California Regional Water Quality Control Board, San Diego Region

April 8, 2015

Subject: Notice of Violation No. R9-2015-0056 and Water Code Section 13267 Request for Technical Report, City of Carlsbad

Facility: Robertson Ranch
Inspection Date: 12/12/2014

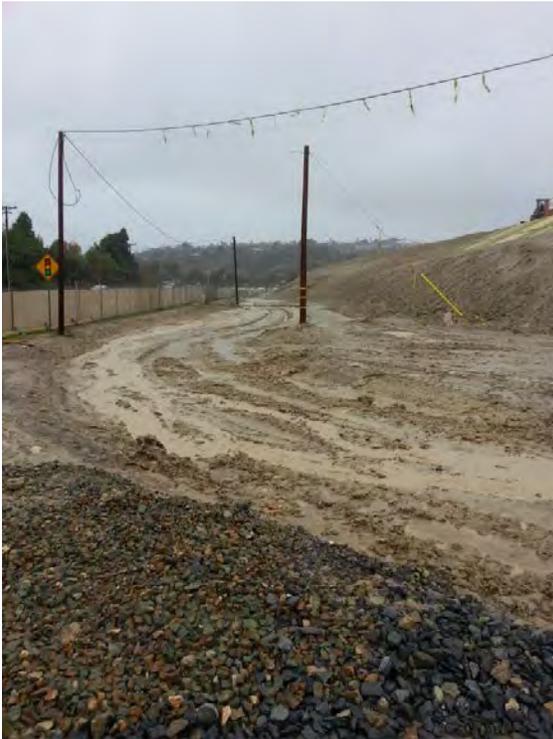
Photo 8: Slopes lacking adequate erosion and sediment control BMPs; erosional gully shown in photo.

Photo 9 No erosion controls present on large slopes. No linear sediment controls on large slopes. No erosion in conjunction with sediment controls present on other areas of site.

Photo 10 Partial erosion control present (i.e. straw blankets) on one large slope. Partial linear sediment controls on a part of the large slope in this photo. No erosion in conjunction with sediment controls present on other areas of site in this photo.

| Tech Staff Info & Use | |
|--|---------------------------------|
| March 2015 – El Camino Real Road Widening Inspection Report and NOV R9-2015-0050 | SM-2024994 |

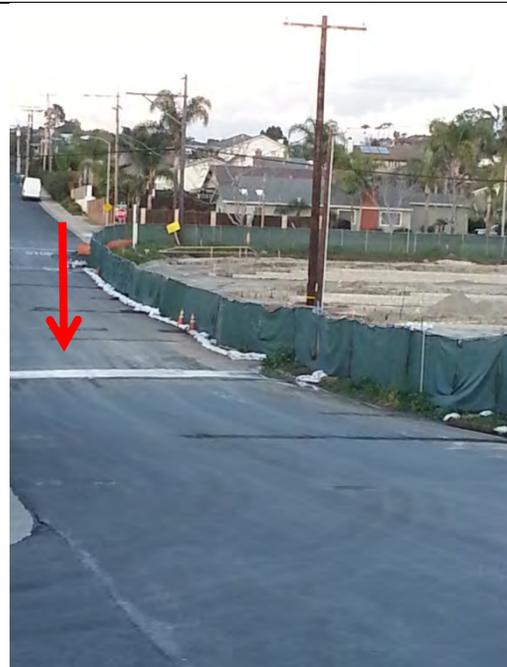
Photo 3- Tracks of sediment shown up and down Oak Ave. Discharge from the site shown by the yellow arrow.

Photo 4 – Evidence of the flow path for discharges from the site to the MS4. Lack of soil stabilization, erosion controls, and sediment controls on the site as seen inside the fence. Stockpiles are not covered and no evidence of sediment or erosion control BMPs

March 26, 2015 Site Photo

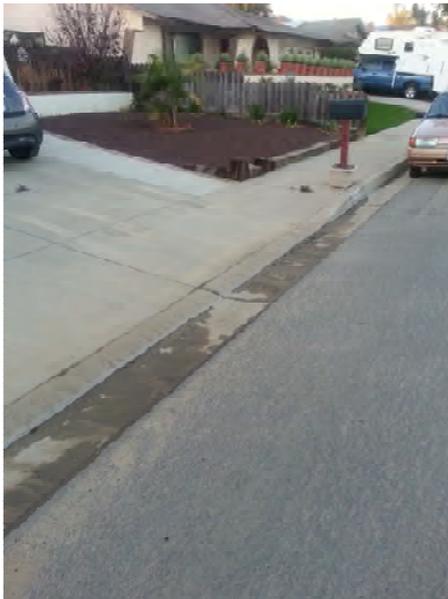
Photo 15 – Wet MS4. Sediment in MS4. Sediment on driveway after car tracked through it. Condition of the MS4 an indication that sediment is not adequately controlled on site.
